# UNITED STATES PATENT AND TRADEMARK OFFICE

APPLICATION NO.	FILING DATE	FIRST NAMED INVENTOR	ATTORNEY DOCKET NO.	CONFIRMATION NO.
10/055,582	01/23/2002	Dennis P. Silver	11899	7015

# Office Action Summary

## **DETAILED ACTION**

FIG. 2

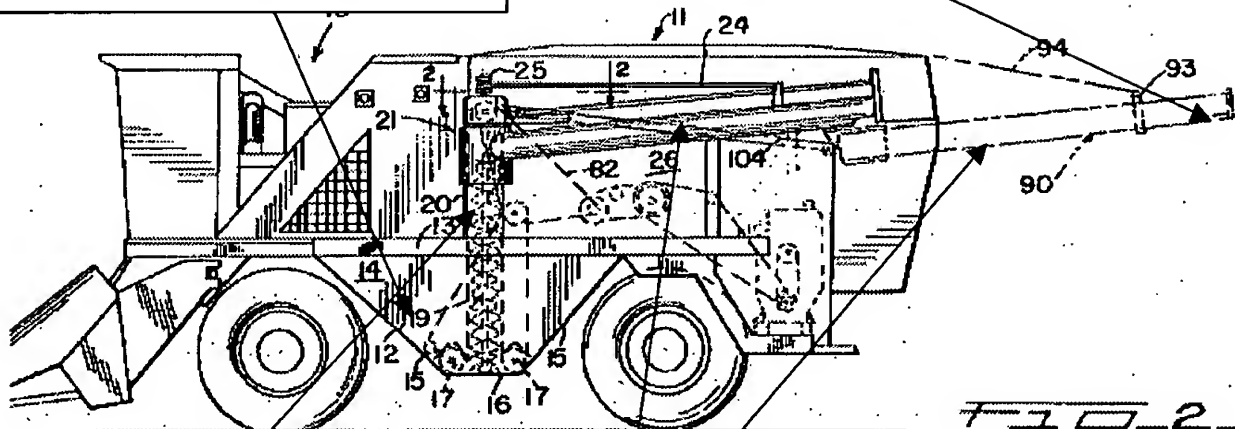
In re independent claims 1 & 6, Pool discloses the claimed invention as disclosed and outlined in the marked up drawings shown below, it is noted however that claim 6 does not have "substantially vertical infeed section coupled to the first segment";

Storage bin of a combine (cl. 6); wherein the storage bin defines an upper surface, and wherein the horizontal section is in communication with the upper surface (cl. 16)

Auger exit (cl. 15)

Substantially vertical infeed section coupled to the first segment (cl. 1)

Substantially horizontally positioned first and second segments of an unloading outfeed auger section, parallel to the combine's longitudinal axis in storage & unloading positions (cl. 1) and manually movable with respect to the storage bin (cl. 6 & 8)

Pool discloses the claimed device except for coupling the first & second segments in a side by side arrangement when in storage by using a hinged connection which can be moved into position by any well known means such as a hydraulic actuator connected between the two segments as claimed.
